CERTIFICATE OF APPROPRIATENESS

Property: 1034 East 14th Street, Lot 9, Block 119, North Norhill Subdivision. The property includes a historic 1,152 square foot, one-story wood frame single-family residence and a detached garage situated on a 5,200 square foot (50' x 104') interior lot.

Proposal: Alteration – Porch Columns and Windows

PORCH COLUMNS

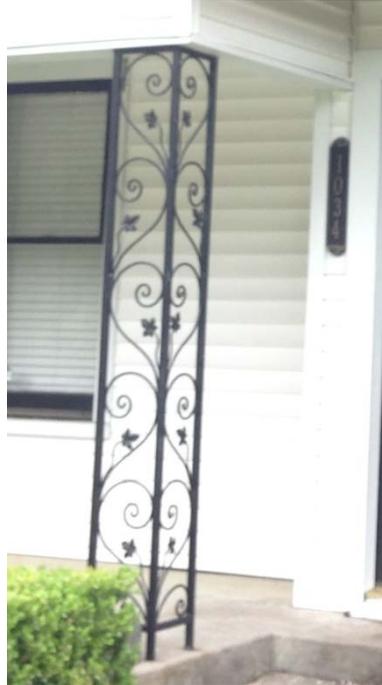
Two non-original porch columns proposed to be replaced

Exterior Materials: Replace the two existing non-original wrought iron porch columns with two square wood porch columns. The new columns will measure 6" thick and 6' 9" tall.

Recommendation: Partial Approval: Approve replacing the porch columns. Deny replacing the windows.

FRONT WINDOWS

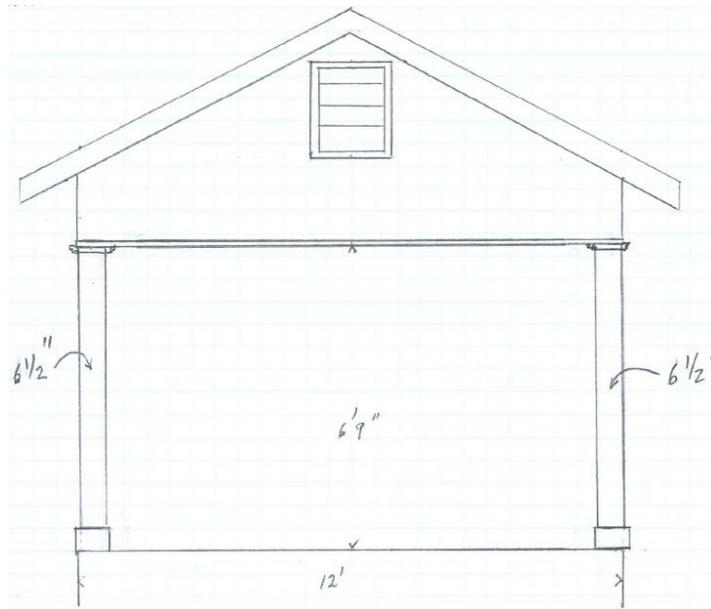
<i>Historic windows are a character defining feature of this residence. Replacing two historic windows with two new windows undermines the character of the property. This is especially true in this instance as these windows are on the front of the residence and are the only two remaining historic windows on the structure.</i></p> |

<i>Historic wood windows are an irreplaceable distinguishing quality of this structure, and other Contributing structures found throughout the Norhill Historic District. Removing undamaged historic windows represents a failure to maintain the structure's distinguishing qualities.</i></p> |

<i>Historic wood windows feature characteristics of skilled craftsmanship no longer readily available, including old growth wood, interchangeable components, metal weights and pulleys. Replacing these undamaged windows with a pair of new windows represents a failure to maintain examples of skilled craftsmanship found on this structure.</i></p> |

<i>Replacing two undamaged windows with a pair of new windows represents a destruction of significant historical and architectural material. The structure's energy efficiency can be improved without replacing the last two remaining historic windows. The National Park Service Preservation Brief 3: Improving Energy Efficiency in Historic Buildings outlines several measures to reduce energy consumption. These measures include</i></p> |

Windows/Doors: Most of the house's original windows have been replaced with vinyl windows. The two exceptions are the pair of 31" wide by 64" tall wood windows at the front porch, which are the last remaining historic windows on the structure.

The applicant proposes to replace these windows with new wood 31" wide by 64" tall wood windows. The applicant has not asserted that these windows are damaged. They propose to replace these windows to improve the house's energy efficiency.
